Memo

RE: Northgate Leelanau Pines Campground, Centerville Township
Site Plan Review Response and Resubmittal

[UPDATED RESPONSE – Selected paragraphs of the memorandum have been revised to reflect comments received in the 10/20/23 Findings of Fact Version 2 and the Planning Commission’s comments received on 10/25/23.](#)

CERTIFICATE OF SURVEY

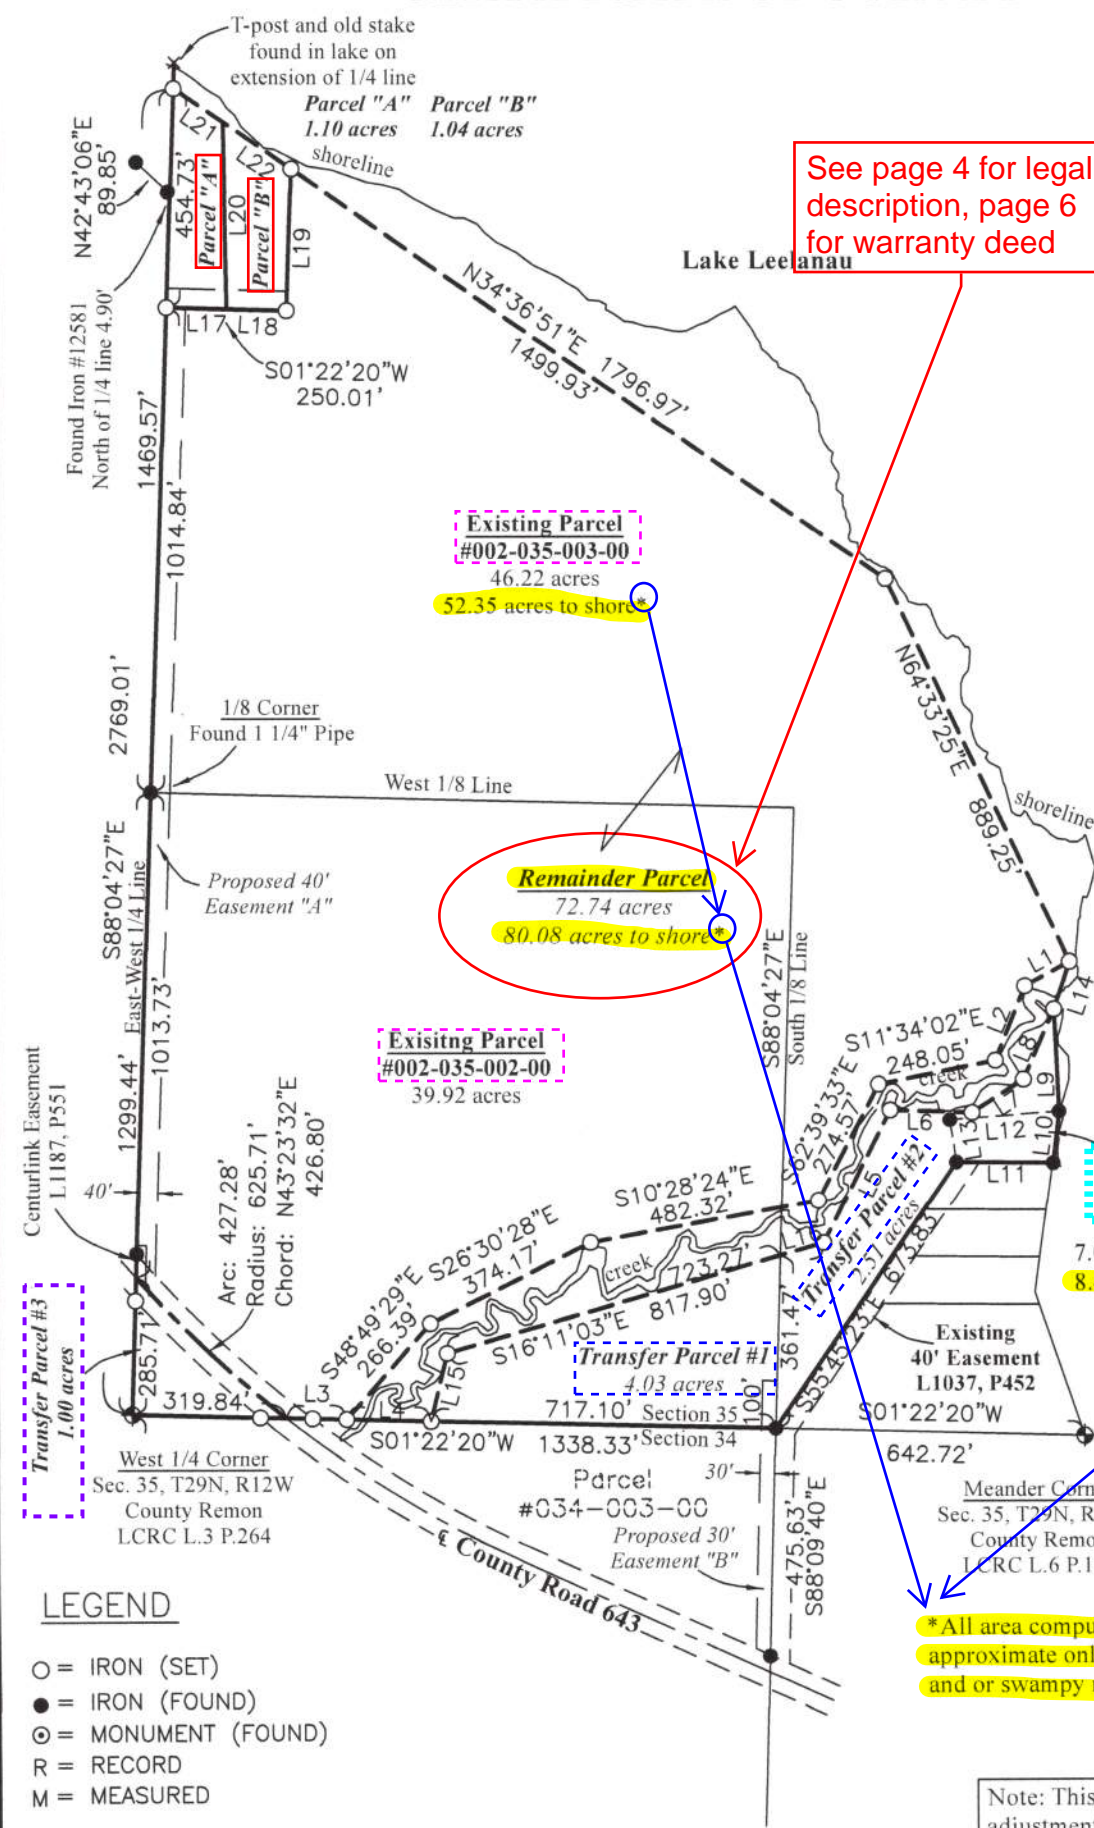
2. The Planning Commission finds that the subject property consists of 72.74 acres (Parcel No. #45-002-35-003-13).

Northgate Response – Correction: the site acreage is 80.08 acres including the land between the intermediate traverse line and the bodies of water (Lake Leelanau and Rice Creek). This acreage was submitted and highlighted on PDF page 11 of 126 showing the Grand Traverse Surveying and Mapping survey of the site (9/29/21).

[UPDATED RESPONSE – The GTS&M survey sketch and descriptions include the property between the traverse line and the water’s edge. The GTS&M survey is referenced in the warranty deed recorded document number 2021009947. A highlighted copy of both documents supporting the 80.08 acres is provided.](#)

SITE COVERAGE PLAN
SCALE: 1" = 100'
NORTH
0 50 100 200

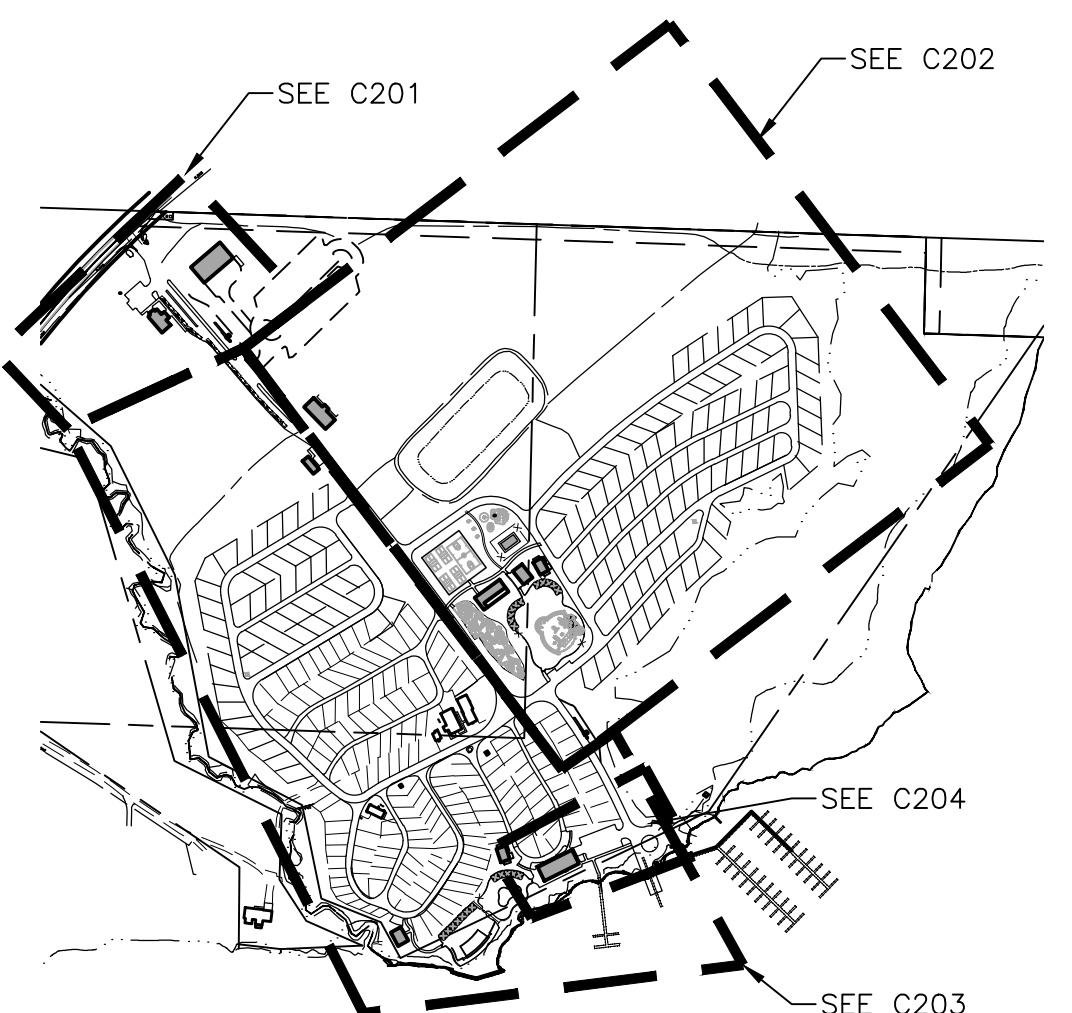
Finding: Proposed lot coverage is not detailed within the revised site plan review application (see Sheet C200, dated 9/1/23). The Planning Commission finds that this standard has not been met, and more information is needed.

Northgate Response: The Lot Coverage calculations have been provided on a new sheet C205 for the proposed campground improvements. A table has been provided to clarify the lot coverage according to the zoning ordinance as well as various interpretations of the term. Including all existing and proposed improvements, the campground lot coverage is 21.58%. This is 3.42% (2.74 acres) less than the 25 percent maximum (20.02 acres) based on the most liberal interpretation.

UPDATED RESPONSE – The Lot Coverage calculations have been further detailed on drawing C205 to provide hatching and areas for each type of improvement and added the park models and glamping pods. We have shown that the lot coverage of all existing and proposed improvements is 21.85% (17.50 acres) less the maximum (20.02 acres) and therefore fully compliant with the 25% requirement.

L101

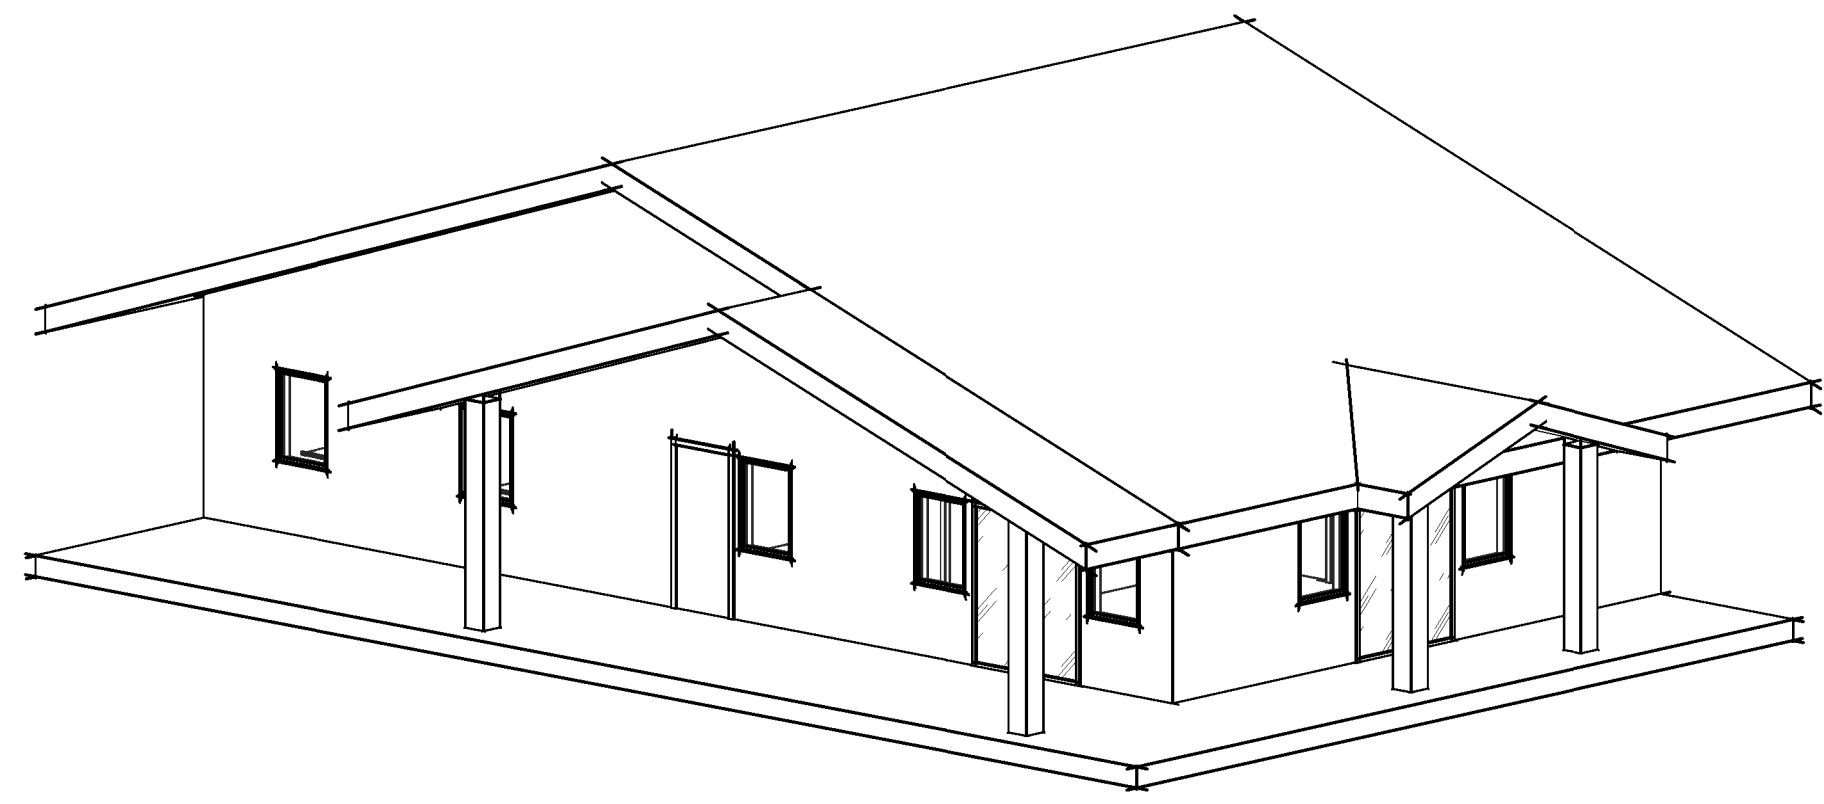
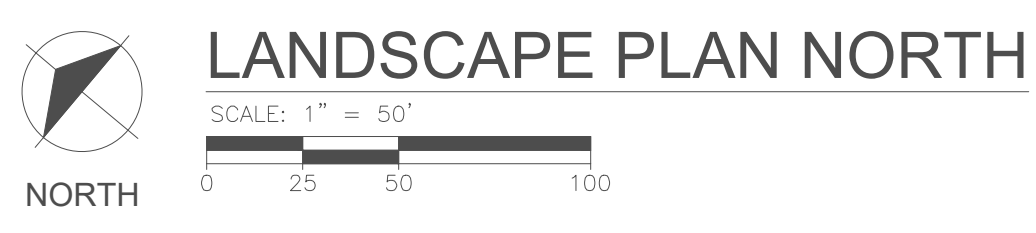
Finding: Applicant proposes one (1) top-lit, entrance sign at 40 square feet, i.e., sign panel at 10 ft by 4 ft on 8 feet high end-posts. The Planning Commission finds that this standard has not been met.

Finding: The Planning Commission finds that this standard has not been met, and additional information is needed.

UPDATED RESPONSE – The site plan will no longer modify the existing sign. We will continue to use the legally non-conforming sign and we have removed the proposed sign improvements from L101.

Northgate Response: Note #4 on the Landscape Drawings (L101-L103) now confirms that all proposed site lights are 22’ maximum height.
